How to update T26SZ

This software updates or alters the functions and features noted below. The instructions and information that follow are meant as a supplement to the original instruction manual that accompanied the T26SZ transmitter. Please refer to the original instruction manual where applicable, but replace the steps indicated below with these instructions. Please check to ensure that the update has been installed.

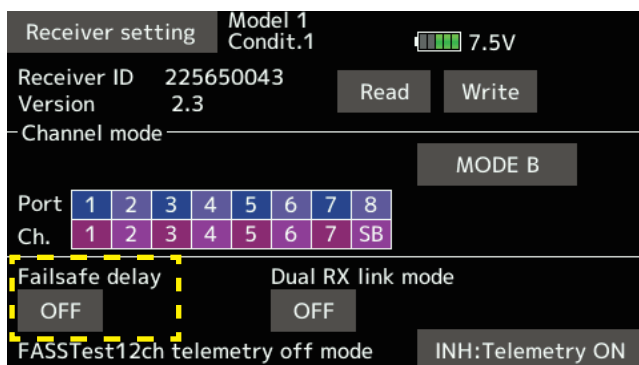
1. Failsafe Delay function newly added.

By connecting a receiver that supports the failsafe delay function, can turn the fail-safe delay function ON/OFF.

This function enables the servo movement softly toward the preset failsafe position when the failsafe activated.

To enable this function, please go to Receiver Setting menu in the "System Menu" of the transmitter.

4. Select ON/OFF for the Failsafe delay function.

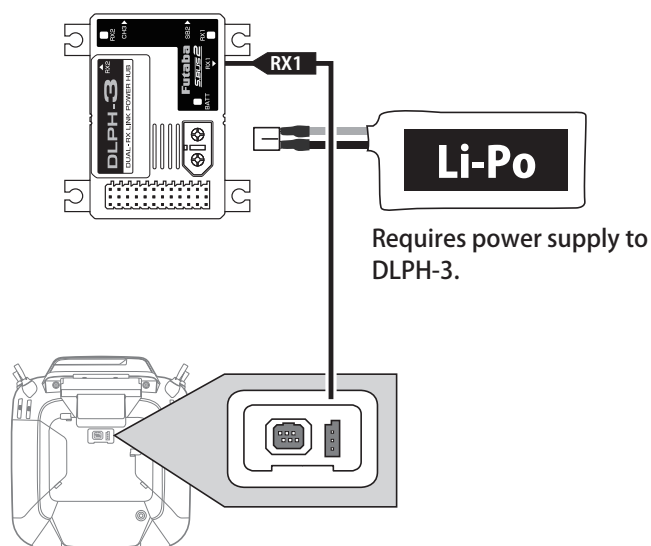
Added Vector Nozzle function for jet models.

Camber mixing setting rate has been expanded from ± 100 to ± 200 .

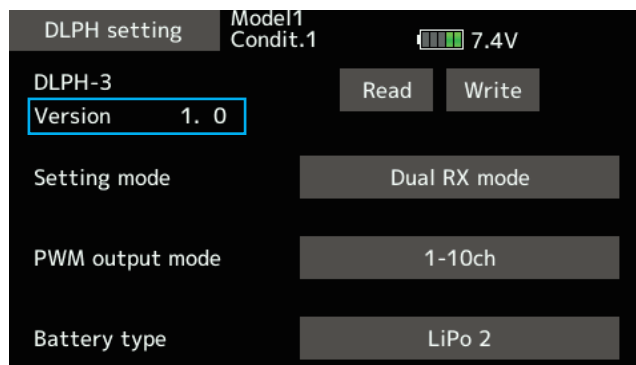
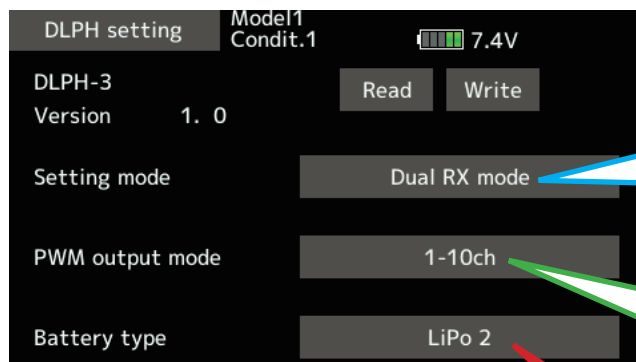
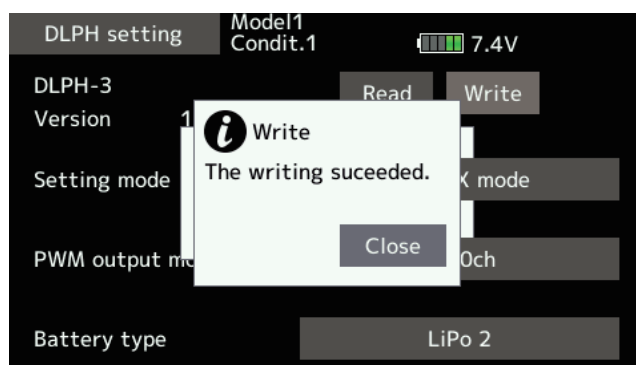
3. Now compatible with Power Hub DLPH-3.

By connecting the DLPH-3 to the transmitter, it is possible to change the mode of the DLPH-3.

④ The version of the connected DLPH-3 is displayed.

⑤ Set the mode of the DLPH-3.
